A BEAZLEY ARCHITECTURE LLC  
104 Dairy Lane  
Broussard, Louisiana 70518

RE: THE HARVEST CENTER CHURCH  
819 E SIMCOE ST.  
LAFAYETTE, LOUISIANA 70501  
PROJECT NO. 2025-006

Issued February 20, 2026

ADDENDUM NO. 2

1 PARKING REQUIREMENTS & LANDSCAPE PLAN  
1/8" = 1'-0"

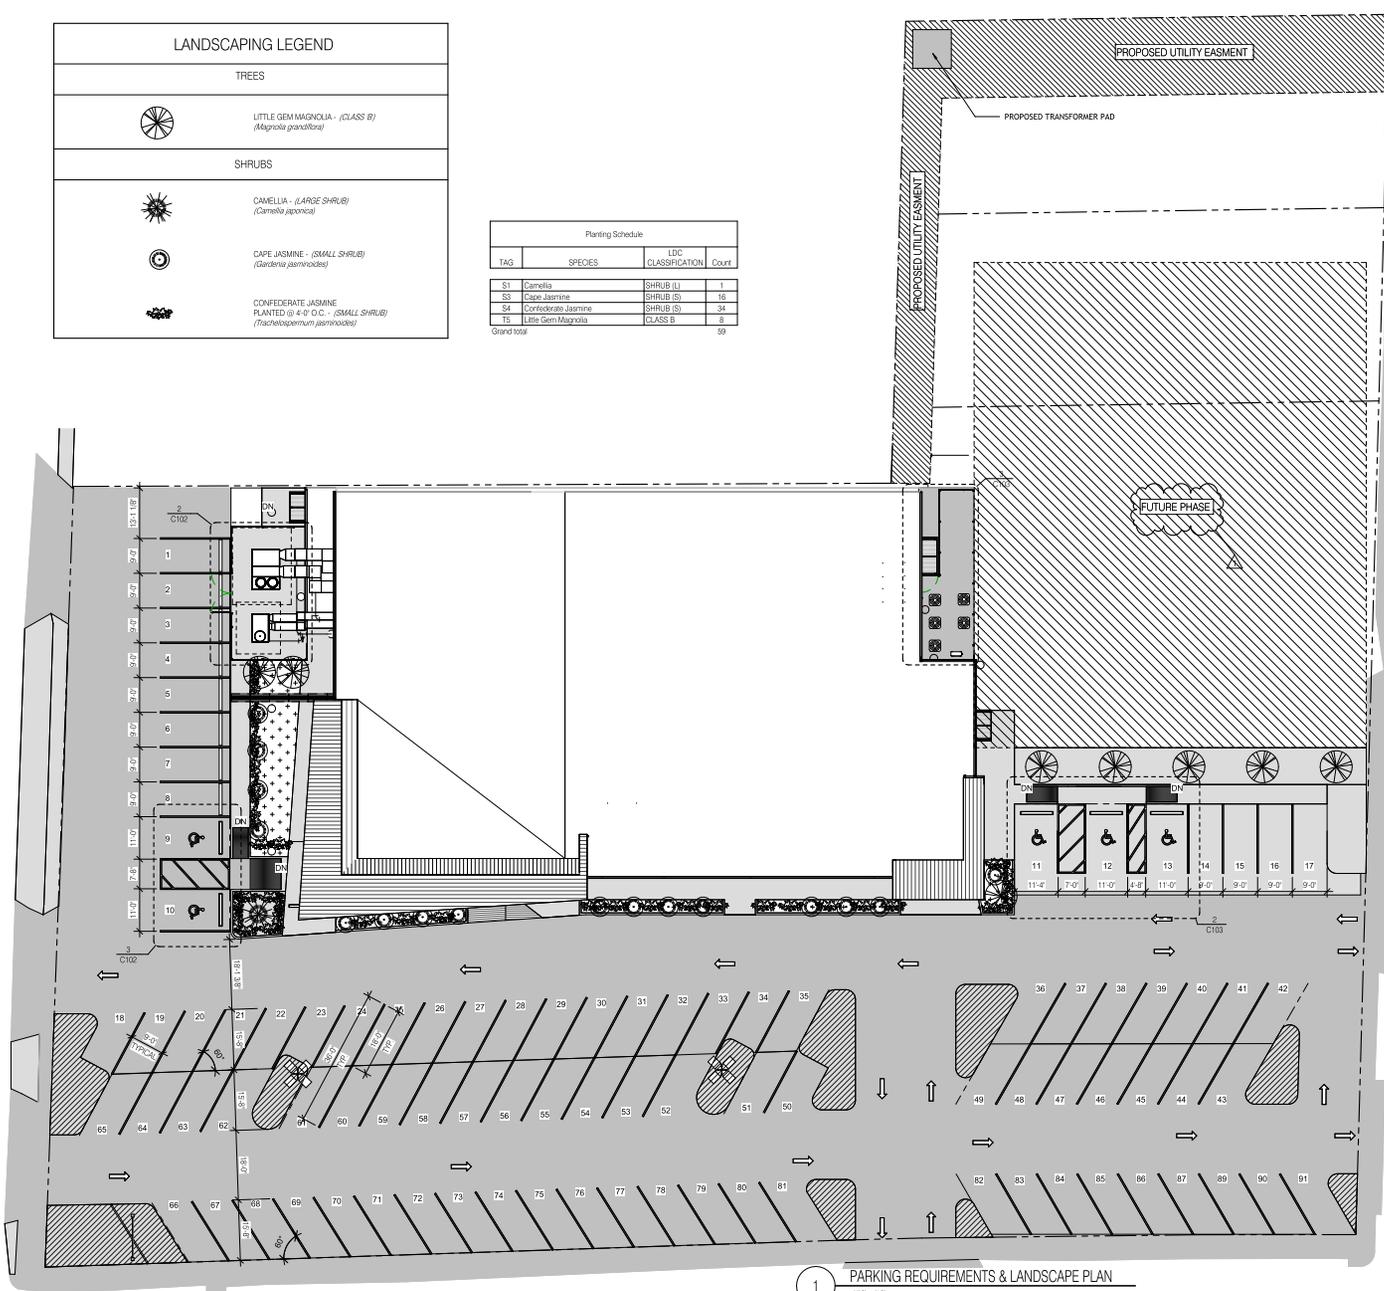
ITEM NO. 8 – SHEET C101r – LANDSCAPE & PARKING REQUIREMENTS:

Replace with revision dated 2/20/26 showing clouded future phase.

1 1ST FLOOR PLAN - DEMOLITION  
1/8" = 1'-0"

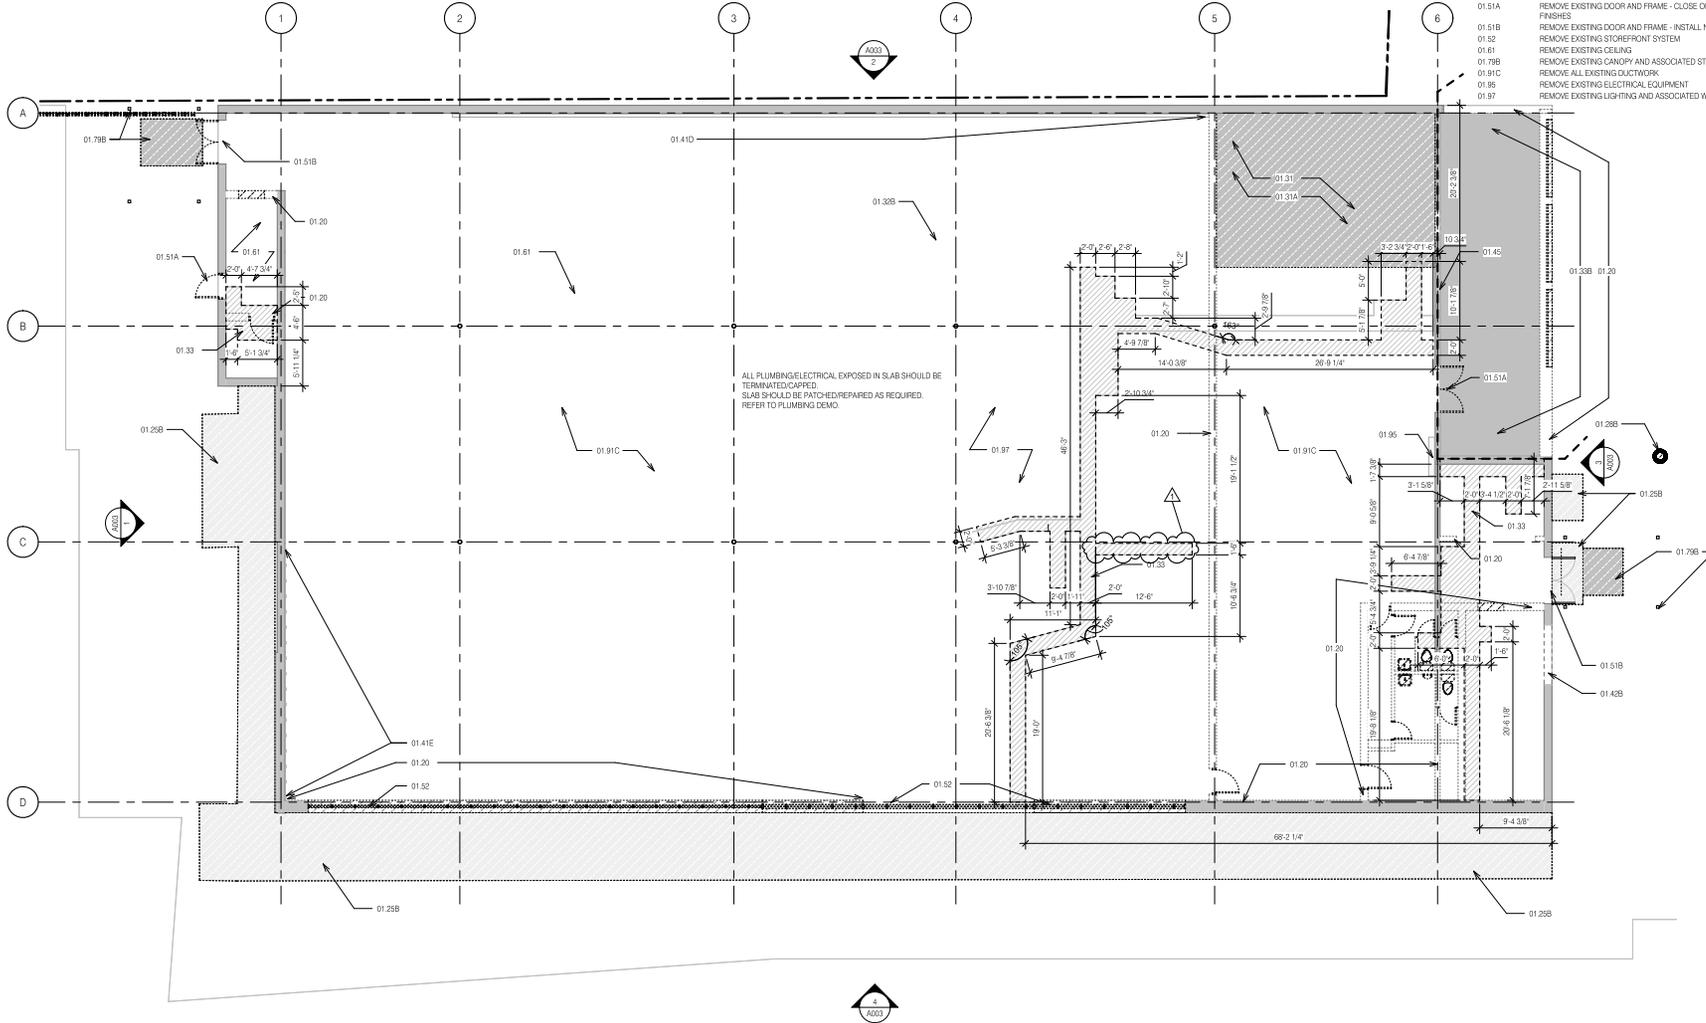
ITEM NO. 9 – SHEET A001r – 1<sup>st</sup> FLOOR PLAN - DEMOLITION:

Replace with revision dated 2/20/26 showing extended concrete demo for additional plumbing fixture.

1 1ST FLOOR PLAN - DIMENSION  
 18" = 1'-0"

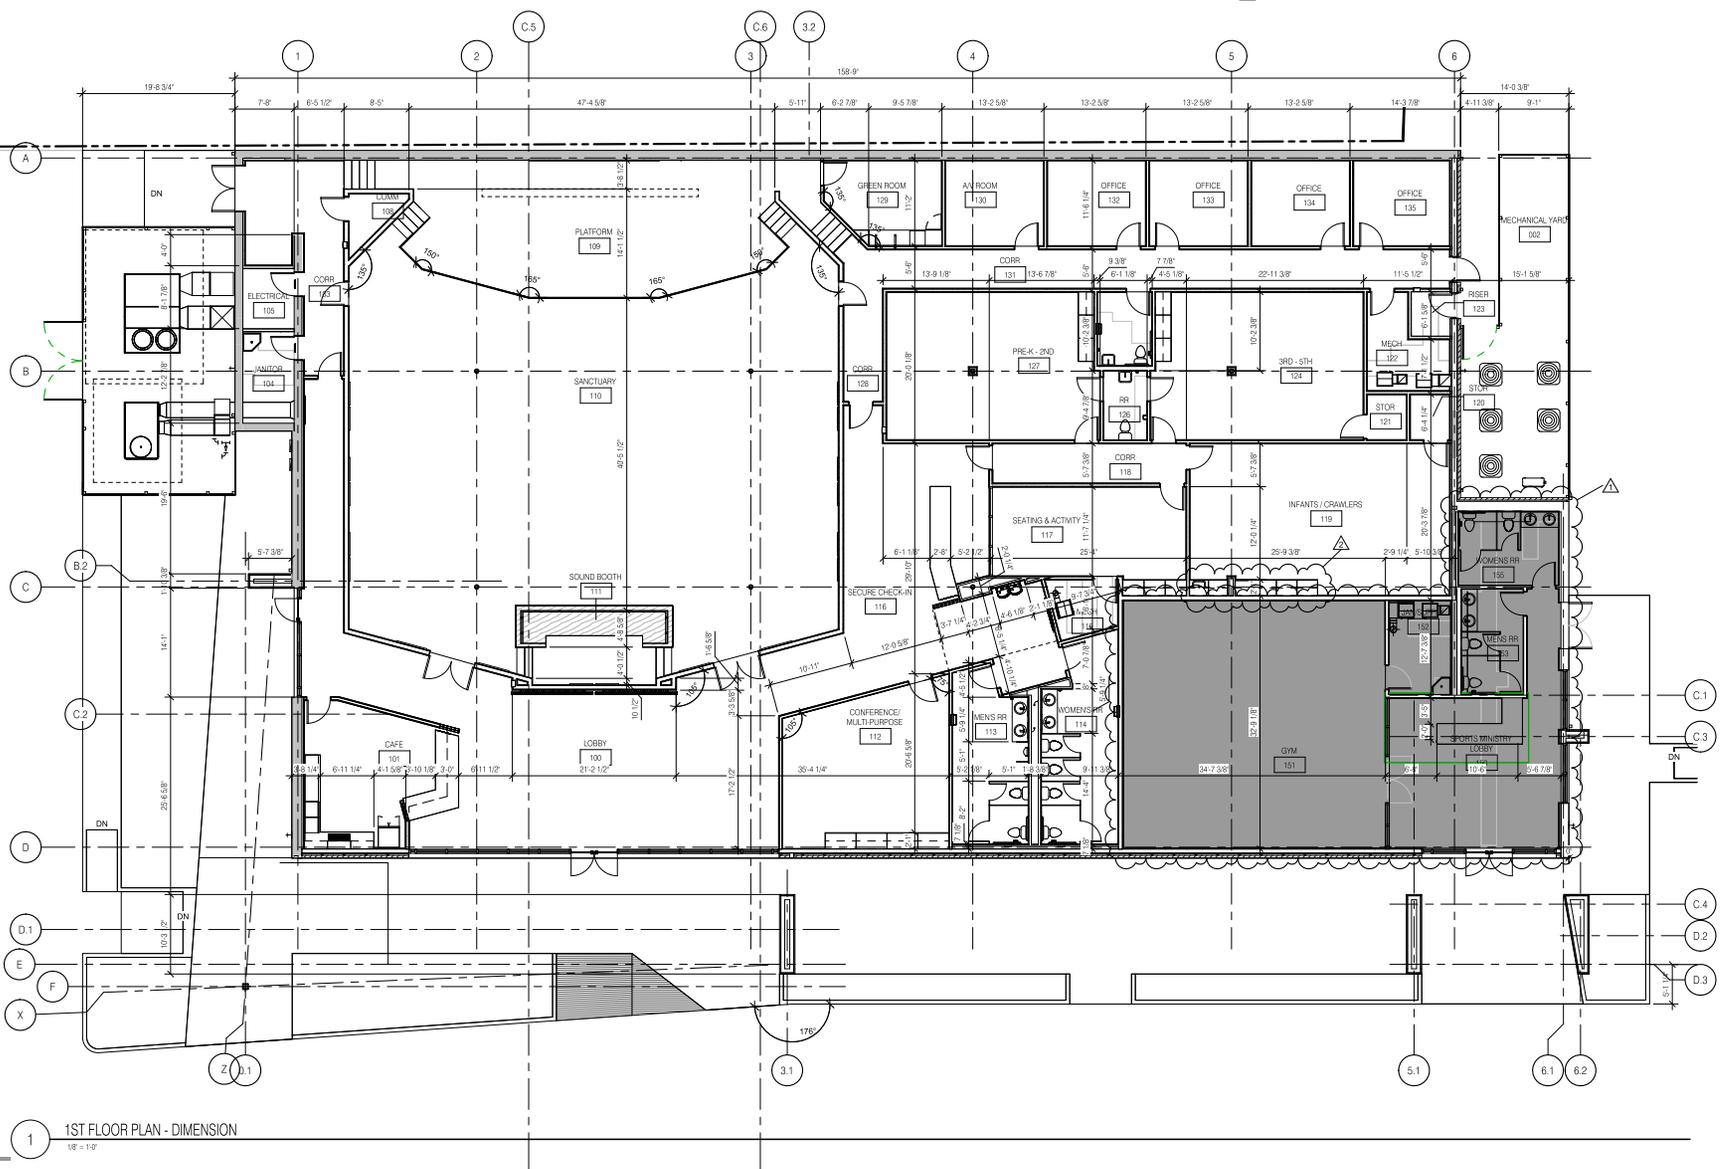
ITEM NO. 10 – SHEET A101r – 1<sup>st</sup> FLOOR PLAN - DIMENSIONS:

Replace with revision dated 2/20/26 with location of new plumbing fixture.

1 1ST FLOOR PLAN - TAGS  
18" = 1'-0"

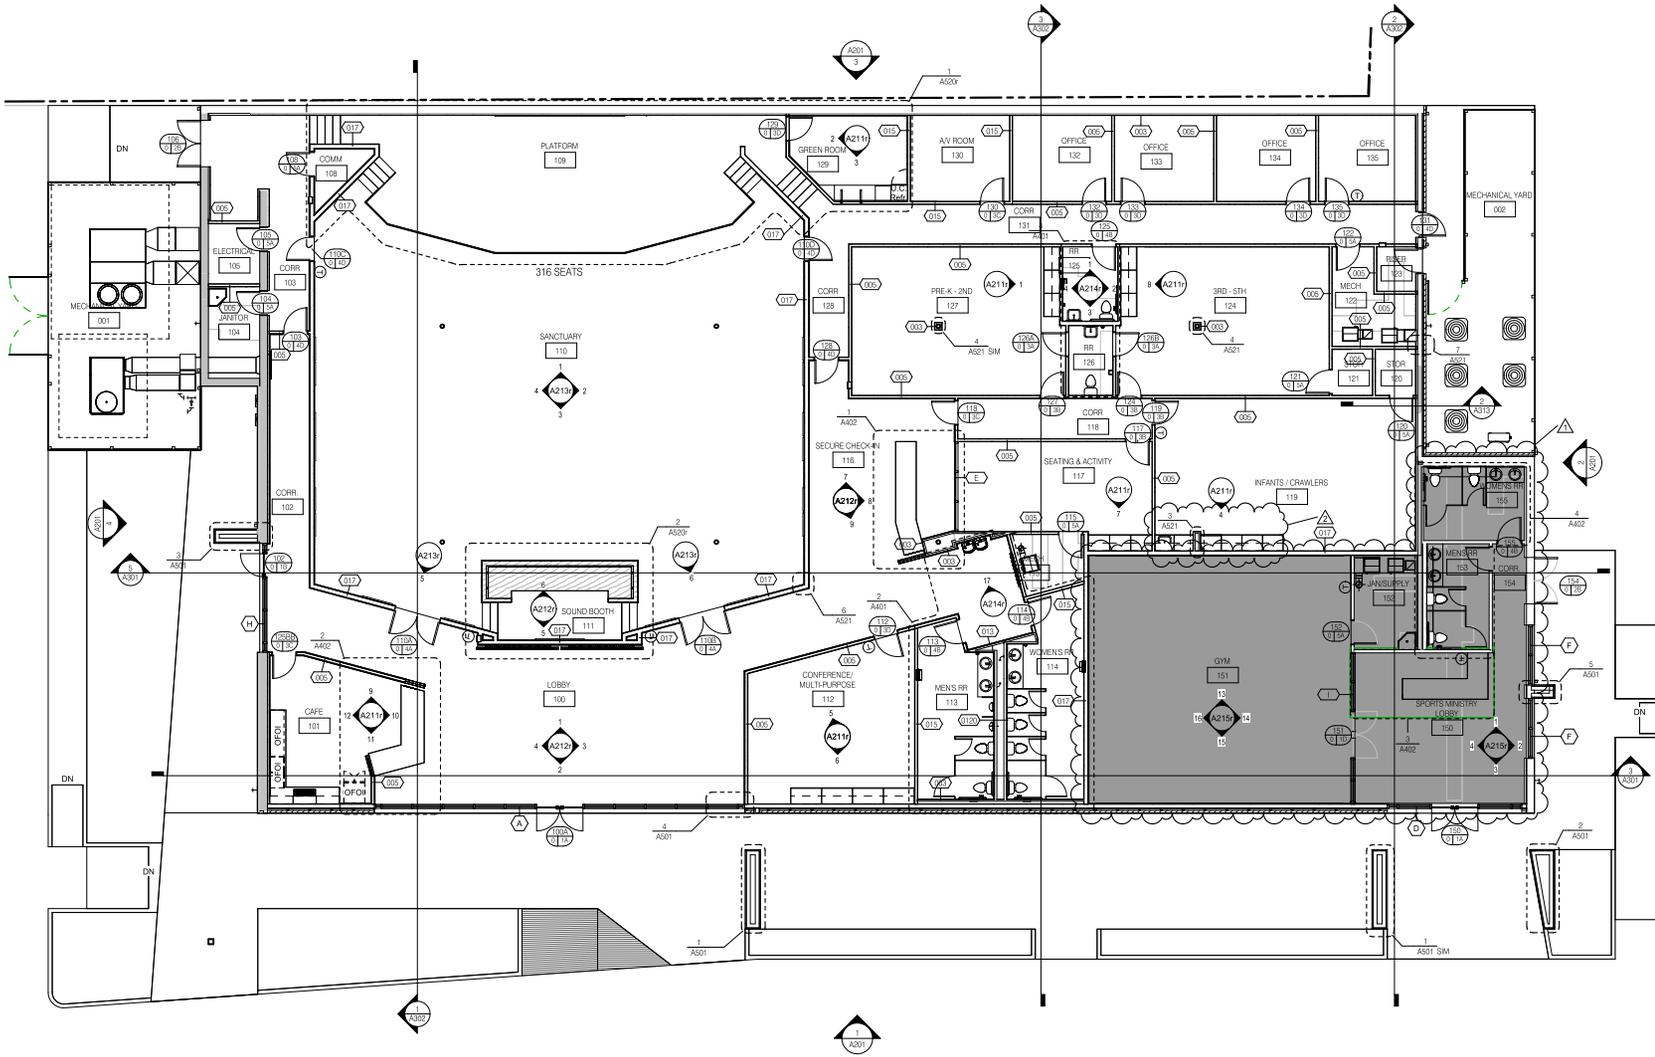
ITEM NO. 11 – SHEET A102r – 1<sup>st</sup> FLOOR PLAN - TAGS:

Replace with revision dated 2/20/26 with location of new plumbing fixture.

4 INT. ELEV. @ SEATING AREA 107 W  
1/8" = 1'-0"

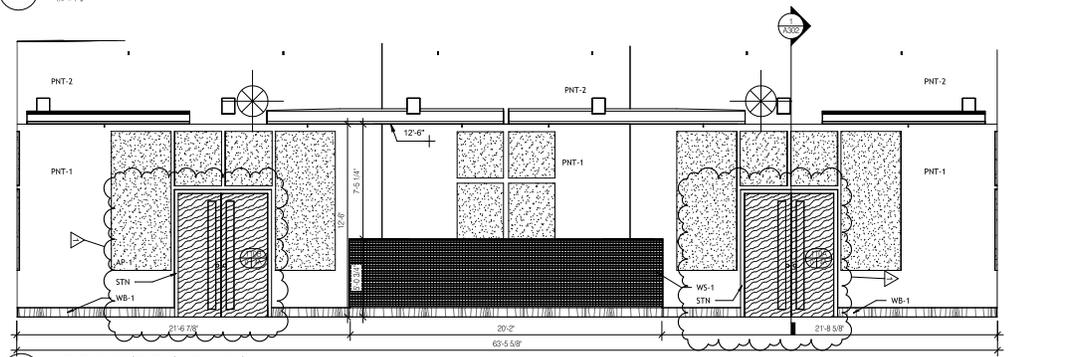
Revised view 4/A211r to incorporate new plumbing fixture, baby changing station, and overall length of cabinet installation.

1 1ST FLOOR PLAN - FINISHES  
18' - 10'

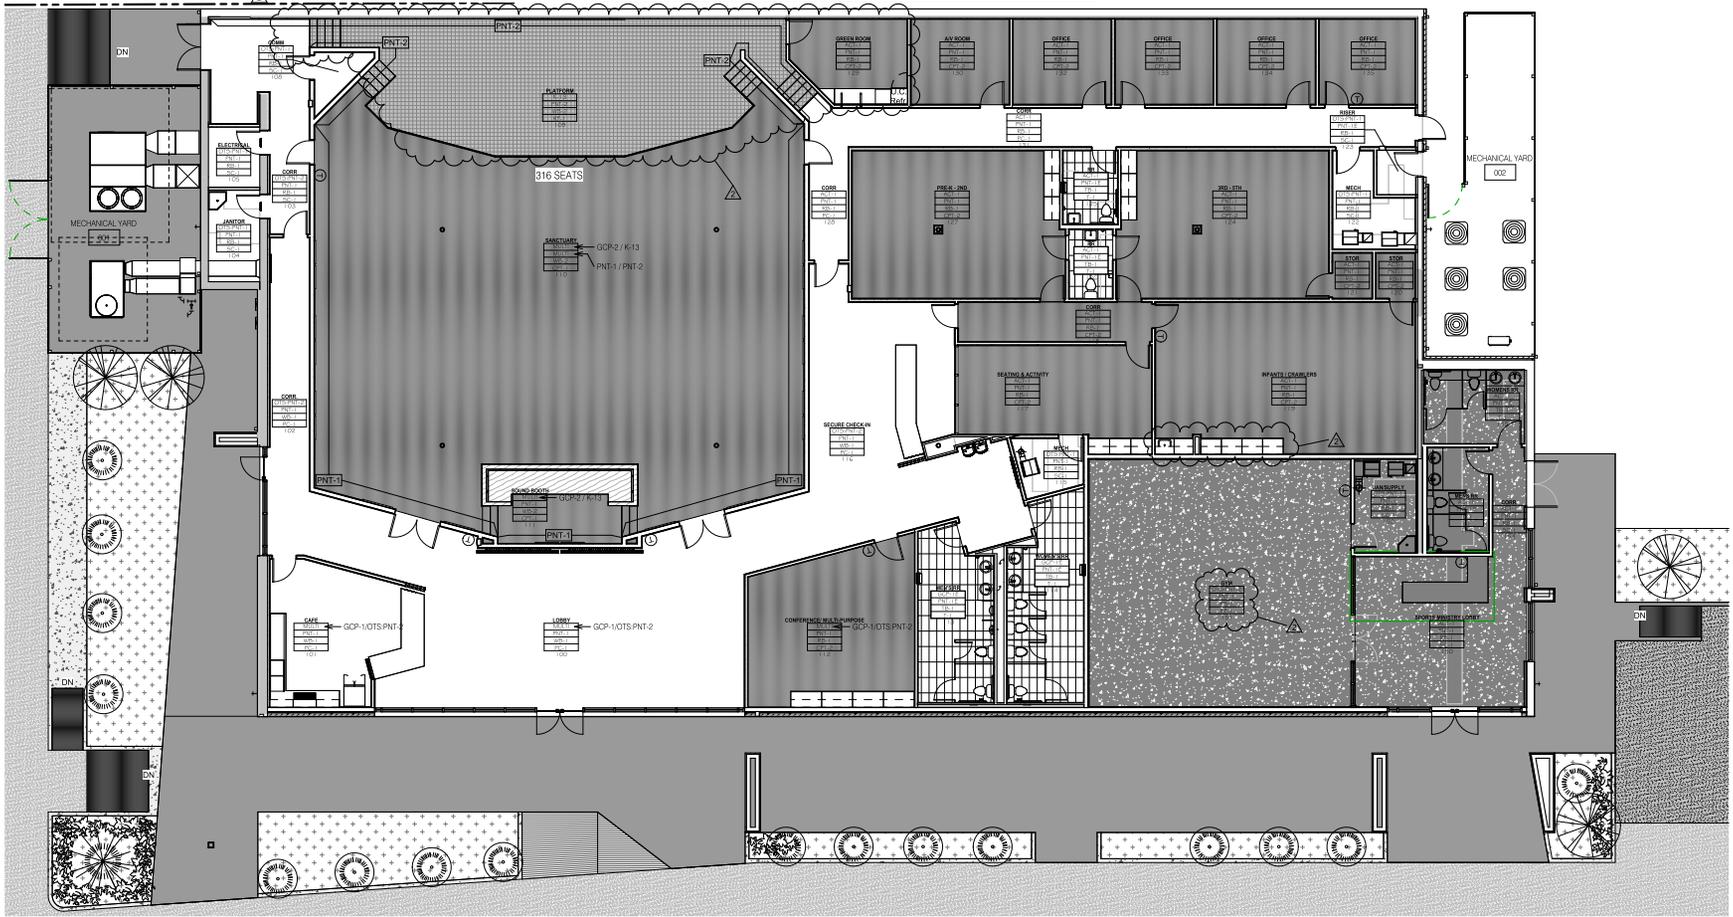
ITEM NO. 17 – SHEET A701r – FINISH PLAN:

Replace with revision dated 2/20/26 showing updated finish schedules and revised material hatch for rubber flooring on platform and stairs, along with location of new plumbing fixture.
